RE: 2018 NC Building Code Section 1001.1 General and 1003.1 Applicability

Re: Request for Formal Interpretation

Rowan Cabarrus Community College Outdoor Classroom Phase II
1333 S. Jake Alexander Blvd., Salisbury, NC

Location Key for Stair Runs

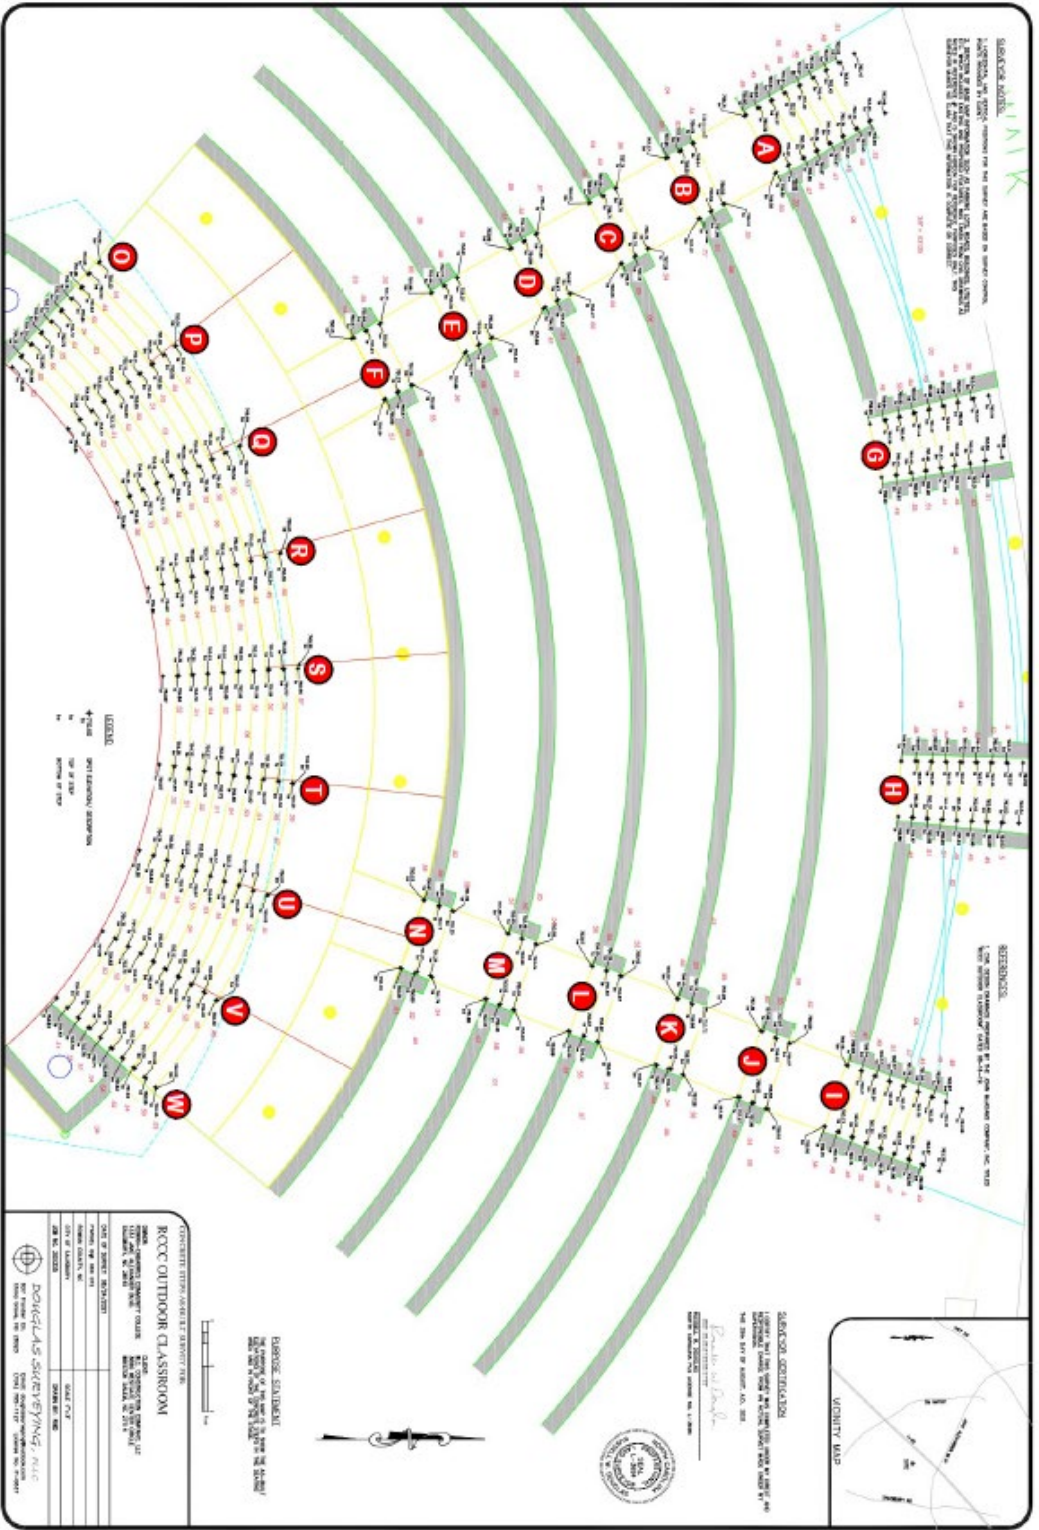
Request No. 1: Whether the steps in the aisles labeled B through F and J through N may be considered landscape steps?

Request No. 2: Without necessarily agreeing that any steps associated with the stage and labeled O through W are considered egress steps that may not comply with the building code (WCCC expressly reserves the right to argue otherwise), to the extent that such steps are considered egress steps that do not comply with building code, can the steps be brought into compliance with the building code with the use of a barrier?

Conclusions: *Since a code-compliant means of egress system is provided via each end of the seating rows to a yard at grade level, stairs B thru F and J thru N are considered landscape steps. Landscape steps are not required to comply with the means of egress requirements of the 2018 NC Building Code. A code-compliant means of egress system from the stage is provided at stairs O and W. With the addition of a barrier along the curved portion of the stage at stairs P thru V, egress from the stage is prevented from stairs P thru V. Since these steps are no longer used for egress, they become decorative steps and are not regulated by the 2018 NC Building code.*
